OIL INDIA LIMITED
(A Government of India Enterprise)
P.O. Duliajan, Pin – 786602
Dist-Dibrugarh, Assam

Addendum No. 6 Dated 03.10.2015
to
IFB No. CDG7573P16

This Addendum No. 6 dated 03.10.2015 to IFB No. **CDG7573P16** for Hiring the Services of 10(ten) sets of Electrical Submersible Pump (ESP) system on rental basis including Operation & Maintenance (O&M) for a period of 3(three) years, extendable by another 1(one) year is issued to notify the clarification/reply of queries of different bidders and also to notify extension of the Sale Date & Bid Closing / Technical Bid Opening date as under:

Tubing Head Adapter Hanger

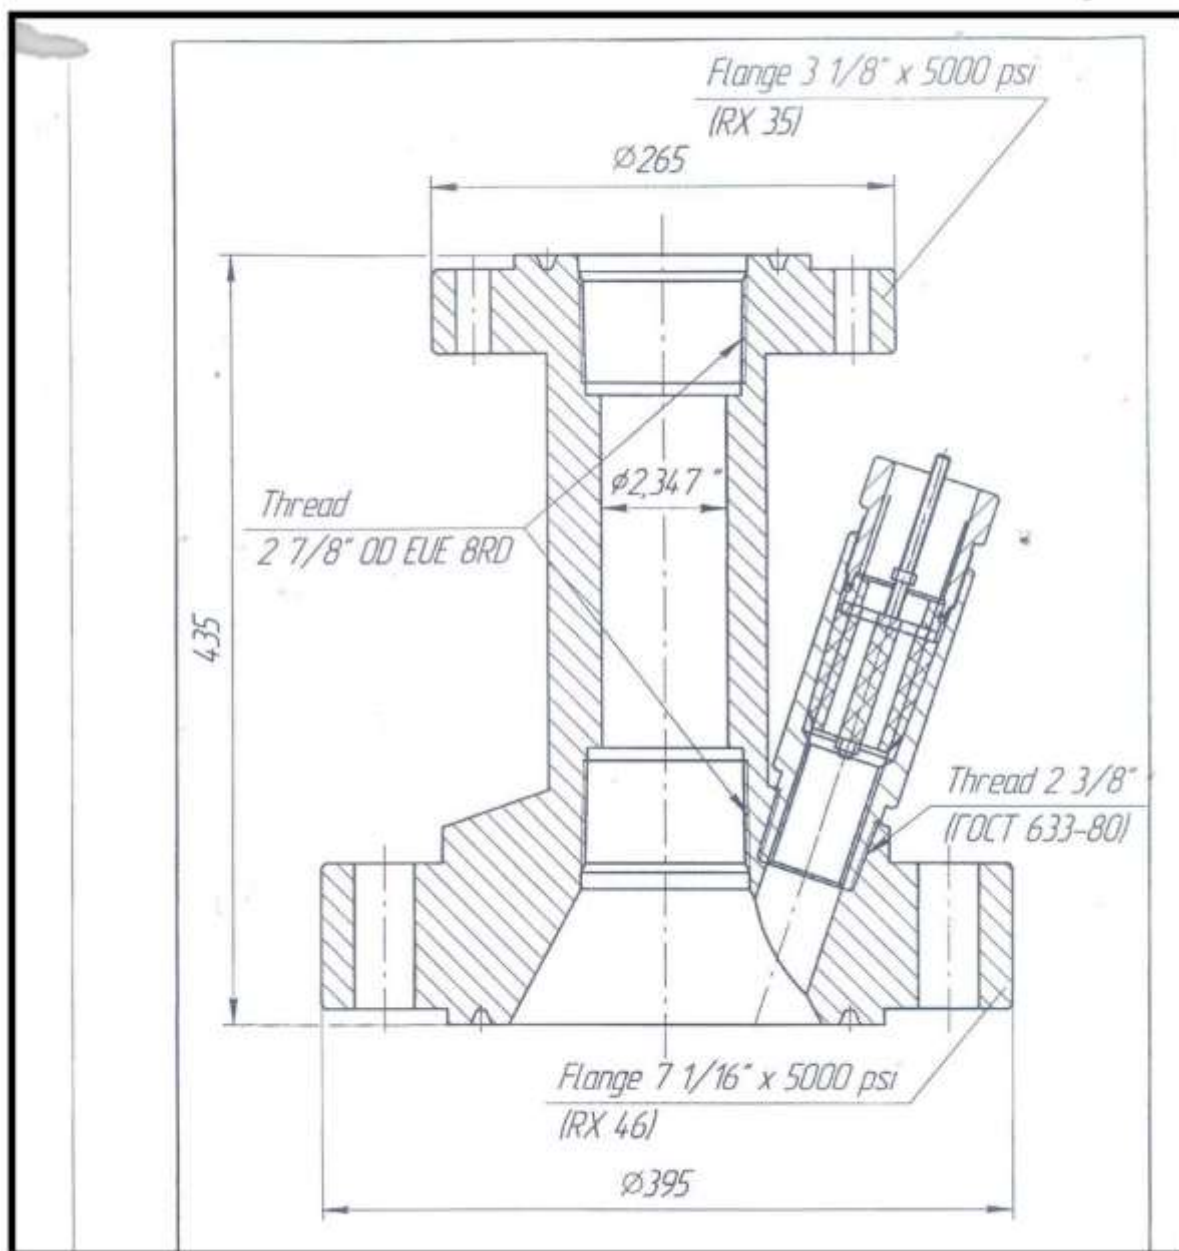
Sl. No	Clause No.	Queries by bidder	OIL's comments
1		Kindly provide detailed specifications of the well-head required.	7 1/16" X 3 1/8" 5K psi rated Adapter flange compatible for ESP installation along with ported tubing hanger to enable ESP power cable entry. (See attached drawing-A for reference)
2		Kindly confirm that X-mas tree is not part of the scope of the tender	X-mas tree is in OIL's scope
3		Kindly confirm that well-head only includes Tubing Hanger	Yes; the well head includes ported tubing hanger to enable ESP power cable entry and to hold the tubing. (See attached drawing -A for reference).
